DRAFT  
3/24/03

ITEM	PART NO.	DESCRIPTION OR SIZE	QTY.
PARTS LIST			
UNLESS OTHERWISE SPECIFIED	ORIGINATOR	P. PFUND	3/12/03
XX XXX ANGLES	DRAWN	K. EWALD	
5.25MM 5.13MM	CHECKED		
1. REPAIR ALL SHARP EDGES	APPROVED		
2. DO NOT SCALE DRAWING	USED ON		
3. SURFACES BASED UPON			
4. MAX. ALL WORK SURFACES			
MATERIAL			
FERMI NATIONAL ACCELERATOR LABORATORY			
UNITED STATES DEPARTMENT OF ENERGY			
LHC INTERCONNECT LAYOUT			
DFBXC-D1/DFBXG-D1			
INTERCONNECT LAYOUT			
SCALE	FILMED	DRAWING NUMBER	REV.
1/4		5520-ME-390XXX	
CREATED WITH 1-DEAS M3T 3b   USER NAME:

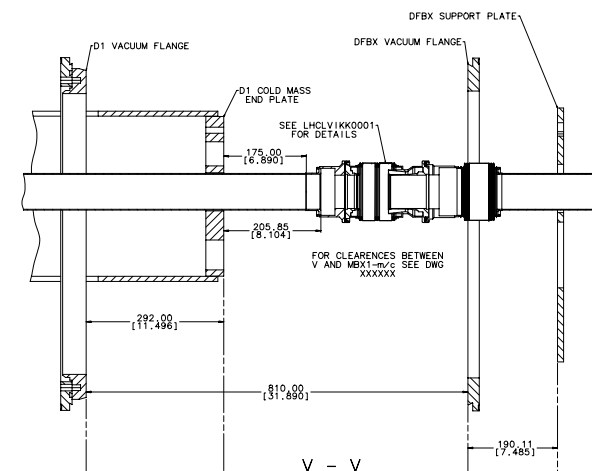
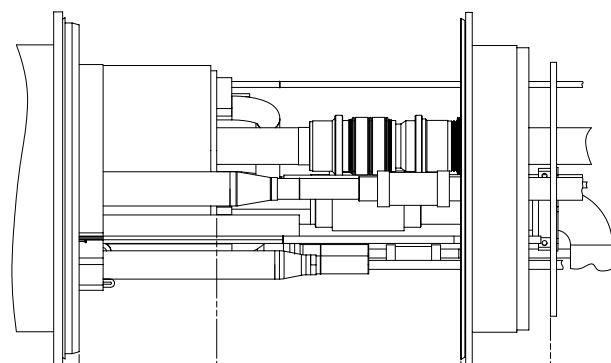
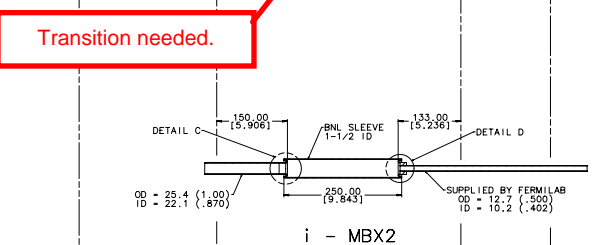
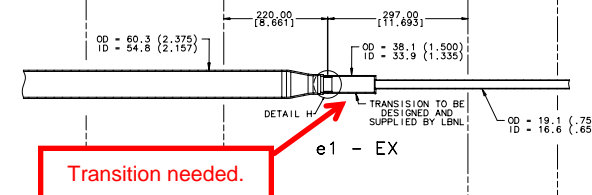
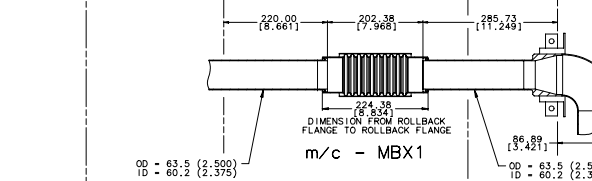
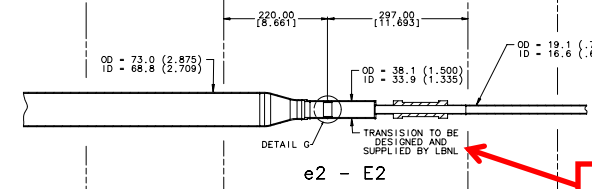
Flex hose is too close  
to interface. Transition  
needed.

Transition needed.

Transition needed.
